SYMBOLGY CONFIGURATION MANAGEMENT CHANGE PROPOSAL FORM			
CHANGE PROPOSAL NUMBER		MIL98-04A	
ORIGINATOR	SPONSOR	DATE RECEIVED	DATE OF ACTION
PM FATDS	ARMY	3 FEB 1999	25 MAR 1999
CHANGE PROPOSAL TITLE			
ADD NEW SYMBOL, SYSTEM RANGE FANS			
SUGGESTED CHANGE			
<p>The Fire Support community has an Urgent requirement to add a new symbol to MIL-STD-2525B.</p> <ol style="list-style-type: none"> <li>1. The purpose of the Range Fan symbol is to graphically display Fire Support weapon and Target Acquisition systems effective ranges to commanders in the Common Operational Picture (COP)/Common Tactical Picture (CTP).</li> <li>2. Recommend adding to hierarchy item 2.X.4, Fire Support, under the "Areas" hierarchy, 2.X.4.3, figure B-17, and table B-IV.</li> </ol> <p><b>Justification for Urgency:</b> Army Battle Command System (ABCS) is made up of six primary (MCS, AFATDS, CSSCS, AMDWS, ASAS and GCCS-A) and a number of extended systems. ABCS version 6.0/6.1 is a go-to-war software. The ABCS is required to be a level 6 DII COE compliant, which includes use of Graphical Situation Display (GSD). GSD with the MIL-STD-2525B capability will be available in DII COE version 4.0. It is anticipated that A

Description: **Fire Support, Area, Weapon/Target Acquisition System Range Fans, Circular**

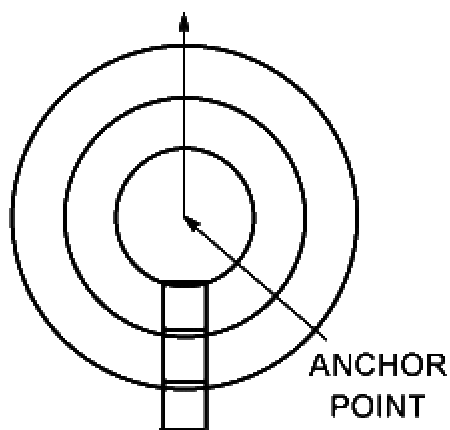
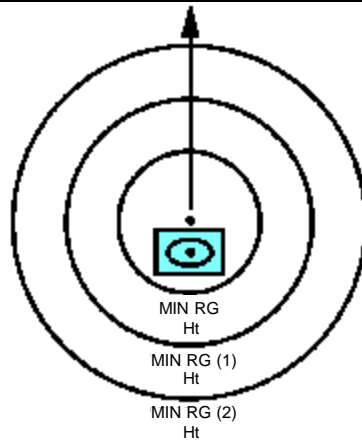
1. Anchor Points. This graphic requires one anchor point that defines an object at a dynamic grid location. This coordinate, which pinpoints the current physical location of a specific unit, weapon or acquisition system, may change with the movement of the object. The symbol for that object is located at the anchor point.
2. Size/Shape. Shapes are concentric circles. Size is defined by the minimum and maximum ranges (as many as required) measured from the anchor point.
3. Orientation. The center point is typically centered over the known location of a weapon or target acquisition system. The orientation of the Circular Range Fan is the direction of engagement. The orientation may change as the object moves or changes.

Fixed/Dynamic: Dynamic, to support requirements that the fan box be transferable between true and relative locations.

Hierarchy: 2.X.4.3.11.1

Symbol ID: G\*FPAXC

Label: Text boxes will be used to label the minimum and maximum ranges and height of the range fan.

Description: **Fire Support, Area, Weapon/Target Acquisition System Range Fans, Sector**

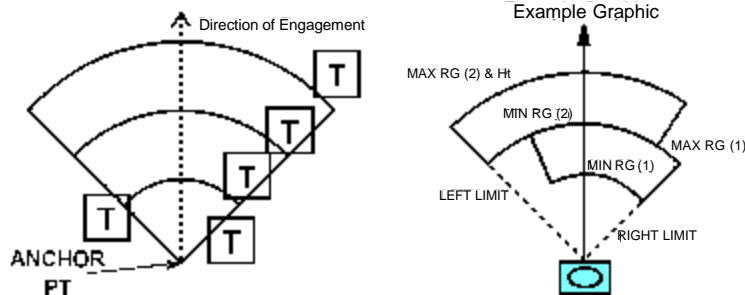
1. **Anchor Points.** This graphic requires one anchor point that defines an object at a dynamic grid location. This coordinate, which pinpoints the current physical location of a specific unit, weapon or acquisition system, may change with the movement of the object. The symbol for that object is located at the anchor point.
2. **Size/Shape.** Determined from the anchor point with a single azimuth that denotes Sector Center. The maximum left and right limits of the sector are measured from the sector centerline. Multiple ranges and/or maximum left and right limits of the sector, as well as height, may be entered, as required, to define the sector.
3. **Orientation.** The center point is typically centered over the known location of a weapon or target acquisition system. The orientation may change as the object moves or changes.

Fixed/Dynamic: Dynamic, to support requirements that the fan box be transferable between true and relative locations.

Hierarchy: 2.X.4.3.11.2

Symbol ID: G\*FPAXS

Label: Text boxes will be used to label the minimum and maximum ranges and maximum left and right sector limits and height.
